**CONTRACT CHANGE ORDER**

No. 5

Contract No. BLDG-2017-18 for the following public work: Fire Storage Building - Training Grounds

**Project:** La Crosse Fire Department Storage Facility

**Proposal Request 12 - REVISED 2/9/18 PR**

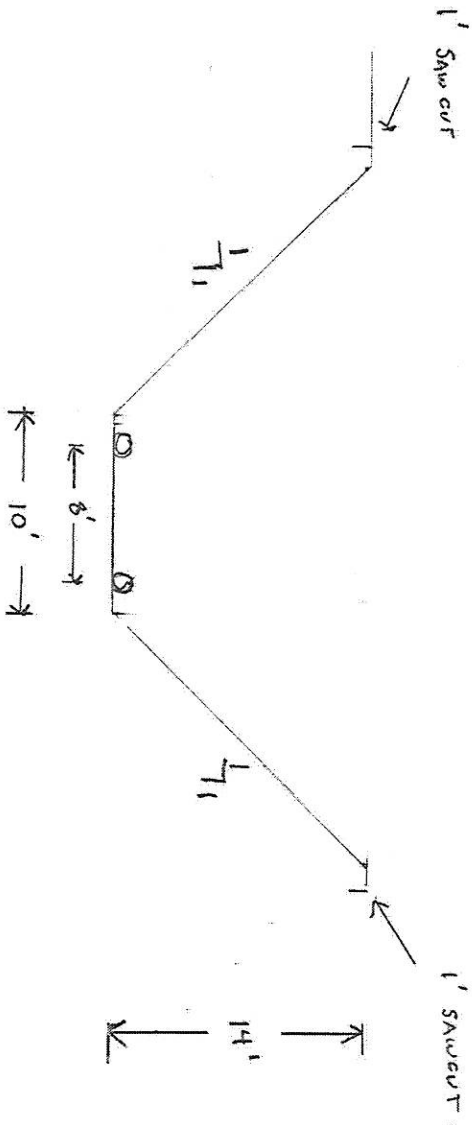
Proposal	
Item #1: Additional Asphalt Paving required, street closure, and painting of Heavy Duty Asphaltic Pavment Patch in Green Bay Street.		
Fahrner Asphalt Sealers, LLC	\$ 250.00	250.00
Central State Signing, Inc.	\$ -1,800.00	40 P.R.
Mathy Construction	\$ 5,591.00	5,591.00
Subcontractor Markup:	\$ -382.05	9,584.00
Item #1 Total Proposal:	\$ -8,023.05	292.05
		\$ 6,133.05

This should have been included in base bid and included in civil plans  
(Per Kris's email on 12-06-17)  
We show pavement removals and replacement based on what we know about existing utilities. GC is required to verify and bring up any discrepancies

38'	EXTRA PATCH	513 sq	ACTUAL AREA IMPACT	3809	AREA SHOWN ON PLAN	7609	ACTUAL AREA IMPACT	3809	EXTRA PATCH	513 sq
-----	-------------	--------	--------------------	------	--------------------	------	--------------------	------	-------------	--------

On our plan we called out an estimated 20' of pavement removal for utility installs but due to the depth of the water (14' rather than the typical 7') the excavator removed an additional 20' of pavement to achieve a 1:1 trench slope during excavation. Brickl stated that when they tore up the additional 20', the adjacent pavement was breaking up and they removed another 27' to create a clean edge and get back to solid pavement. Because the need for additional pavement was not made aware to ISG or City prior to or during the work, we feel it is fair to pay 100% for the additional 20' of paving required for excavation and 50% of the 27' of additional pavement removed to create a clean edge. Let us know if you need any additional information or have any additional questions.

$760 \text{ sq ft} \times \$6,133.05 \times .42 = 2,575.88$   
 $1026 \text{ sq ft} \times \$6,133.05 \times .58 \times .50 = 1,778.58$   
 revised. **\$ 4,354.46** Put this 2/9/18

**APPROVED AMOUNT**  
GPK 02-12-18
